Access Compliance Report

Public Rights-of-Way

(Pedestrian Signals)

Intersection ID: N/A	Main Street:	Cross Street: N/A	Location: N/A
ADA ID: C78D30E3A490	Signal Type: One Push Button-APS	Overall Compliance: No	Severity Score: BTN 1: N/A BTN 2: N/A No BTN: N/A
Codes/Mitigation Info/Possible Solution		Field Measurements/Component Compliance

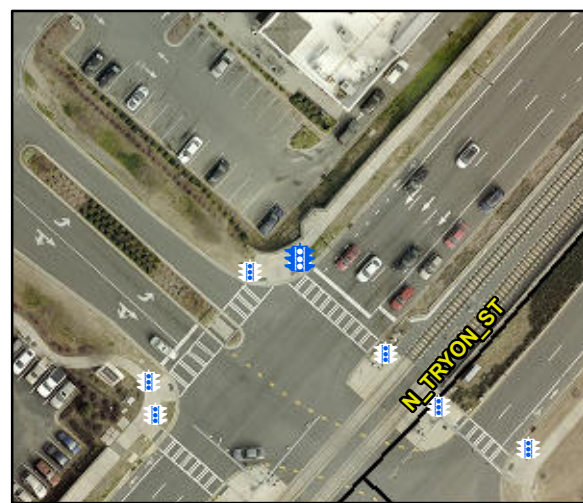
PROW/ADA: TMUTCD 4e.08, R404.2, R404.3, R404.7.3, R404.7.2

N/A B 1 Clear Xing Direction?	Yes	N/A B 2 Clear Xing Direction?	N/A
B 1 Crossing Direction	To SE	B 2 Crossing Direction	N/A
No B 1 DistanceTo XWalk (in)	70.0	N/A B 2 DistanceTo XWalk (in)	N/A
No B 1 DistanceTo Curb (in)	79.0	N/A B 2 DistanceTo Curb (in)	N/A
Yes B 1 Diameter (in)	2.0	N/A B 2 Diameter (in)	N/A

Possible Solutions: Replace Signal Push Button With APS Button on New Post. Remove & Relocate Sign.
